CITY PLAN COMMISSION STAFF REPORT

CD-CPC-2025-00189

46th and Walnut Apartments

Development Plan (Residential)

sheet number:
C2.1
 Grading Plan
 drawing type:
 Development Plan
 project number:
 25010

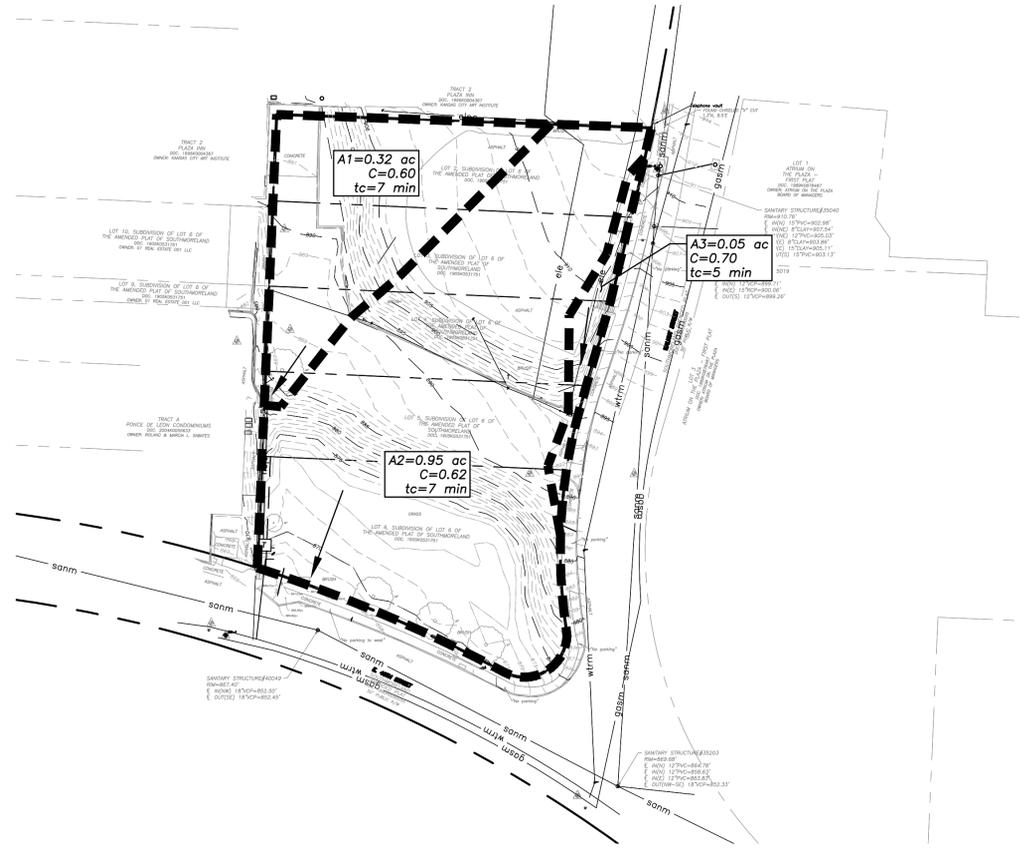
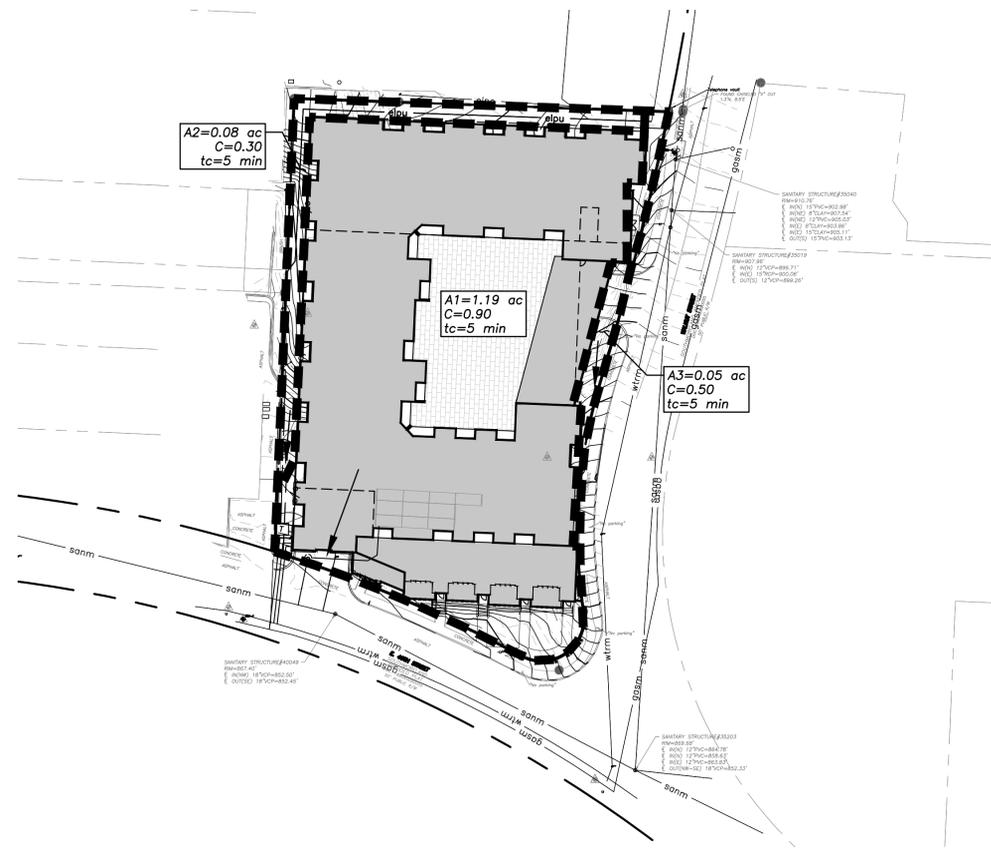
The overlay allows a maximum height of 65 feet on the subject property. The plans propose a maximum height of 109.5 feet. There is significant grade change across the site, approximately 40 feet, which is the main reason for the excessive height due to the consistent roof line of the building despite the grade change.

6. The developer shall pay a partial fee in lieu of \$3,700 to meet landscaping requirements prior to certificate of occupancy.
7. The developer shall receive a variance to the maximum height allowed in the Main Corridor Overlay prior to Council approval.
